Docket Number 2019-184-E

**DIRECT TESTIMONY OF
DEREK P. STENCLIK
SOUTH CAROLINA COASTAL CONSERVATION LEAGUE AND
SOUTHERN ALLIANCE FOR CLEAN ENERGY
DOCKET NO. 2019-184-E**

This report supports the testimony of Derek P. Stenclik related to South Carolina Public Service Commission Docket No. 2019-184-E. It was prepared on behalf of South Carolina Coastal Conservation League and the Southern Alliance for Clean Energy (SCCCL/SACE).¹ Specifically, this document reviews Dominion Energy South Carolina (DESC)'s proposed Variable Integration Charge (VIC) and the related testimony of Dr. Matthew W. Tanner. Dr. Tanner's testimony included the August 2019 Navigant report titled "Cost of Variable Integration" prepared for DESC, which is reviewed in detail throughout this report (herein referred to as the "Cost of Variable Integration study").

Figure 2: 2018 DESC 10-Minute ACE Data

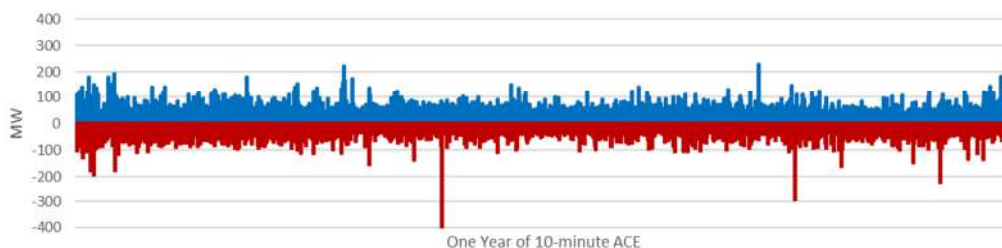
as power flows across the grid faster than a utility can balance the grid. That is why NERC standards allows for some degree of inadvertent and unscheduled flows. This would only increase ACE slightly until DESC could rebalance. Below is a chart of 2018 10-minute ACE values for DESC (formerly DESC),²² showing that imbalances often exceed 100 MW.

Figure 2, references previously, illustrates the amount of inadvertent flows (measured as area control error) between DESC and neighboring utilities. More importantly for the production cost analysis, there are additional economic imports and exports between DESC and neighboring utilities, highlighting the fact that DESC does not always need to be self-sufficient and modeling such a requirement is inaccurate and likely results in overestimating solar integration costs.

Recommendation: The Commission should direct DESC to utilize a more appropriate 95% confidence interval for the solar operating reserve requirements when calculating variable integration costs.

Figure 3: Fairfield Pumped Storage Reserve Capability

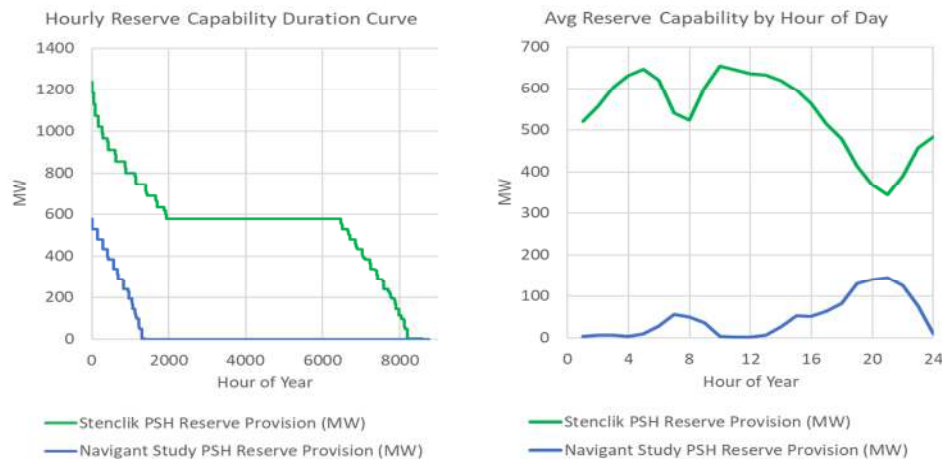
Fairfield has additional reserve capability that could be used for integrating solar generation. The Fairfield Pumped Storage plant can switch from pumping to generating in less than 15 minutes.³⁰ That is too slow to allow Fairfield to be counted as a non-spinning contingency reserve, but it is much faster than necessary for reserves to cover errors in solar forecasts.

The 2030 All Solar PROMOD case results show the Fairfield reservoir level above 576 MWh (1 hour of generation at full output) for 7593 hours. That would allow an additional 6223 hours per year of 576 MW reserve supply in addition to the 1336 hours that is already credited for on-line generation reserves. The Fairfield reservoir could also provide partial reserve capability when the reservoir is below 576 MWh.

In addition, pumped storage technology is especially flexible because it can act as both an electrical load (when pumping) and a generator. If the plant is pumping when there is a drop in solar generation it can stop pumping and effectively reduce system load. This is a valuable form of “demand response” and an effective load reserve that should be counted. As discussed above, the plant can switch from pumping mode to generation mode in less than 15 minutes. The reserves when pumping can there be 200% of the nameplate capacity because it can stop pumping (effectively reducing system load), and then add generation. The max reserve capability is therefore 1,240 MW, much higher than the 576 MW assumed by Navigant.

When this flexibility is accurately considered, the total reserves available from Fairfield PSH increases from 412 GWh in the Navigant analysis (47 MW on average), to 4,763 GWh (544 MW on average). The Fairfield PSH plant could therefore provide 83% of the total reserves required by the Navigant study. The daytime portion of the remaining reserve requirement equates to approximately 52 MW on average, which could be more than accounted for by the 100 MW of available interruptible load. Figure 3 provides a comparison of the Fairfield Pumped Storage reserve capability in the Navigant PROMOD simulations versus calculations that fully account for the plant's flexibility.

Figure 4: Hourly Net Interchange for DESC to Neighboring Balancing Authorities 2018 – 2019

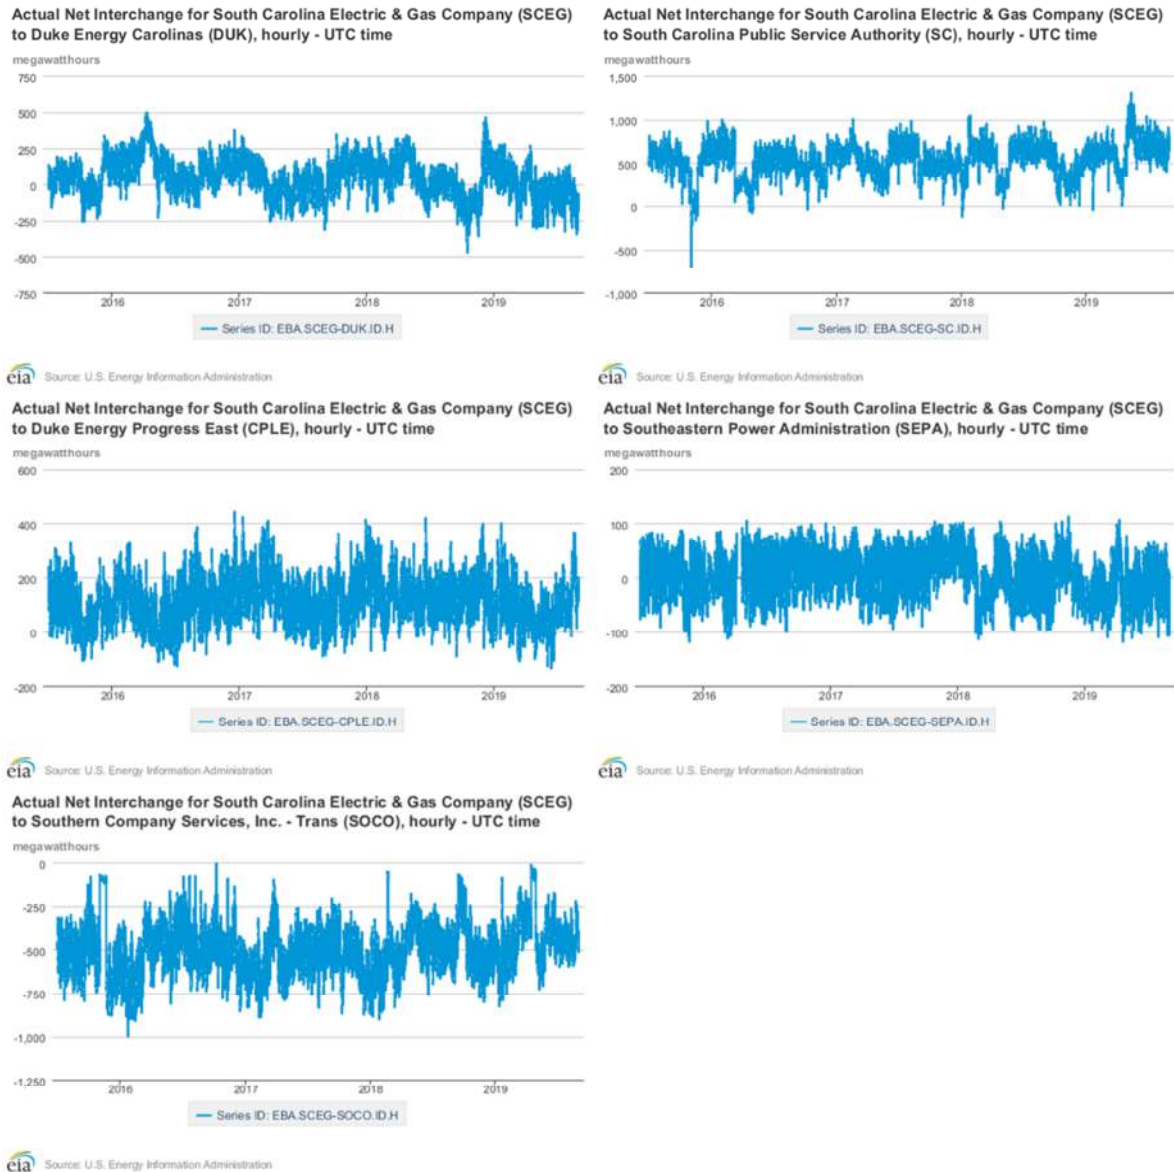
Based on data from EIA,³² DESC regularly imports and exports power from its neighbors. This is illustrated in the charts below, which provide net interchange between DESC and each of the neighboring balancing areas. This data is illustrated in Figure 4, which shows one year of hourly imports and export GWh and count of hours between DESC and neighboring balancing authorities.

When asked if DESC operates as an isolated system, as suggested in the Navigant report, DESC recognized that DESC does not fully operate as an isolated system,

Recommendation: The Commission should direct DESC to model their system accurately, including the economic and reliability interchange between regions. DESC should model neighboring balancing areas to the same level of detail in the production cost analyses to accurately capture the benefits of interchange. At a minimum, DESC should use “proxy-generators” to simulate the availability of economic imports and exports in subsequent variable integration analyses.
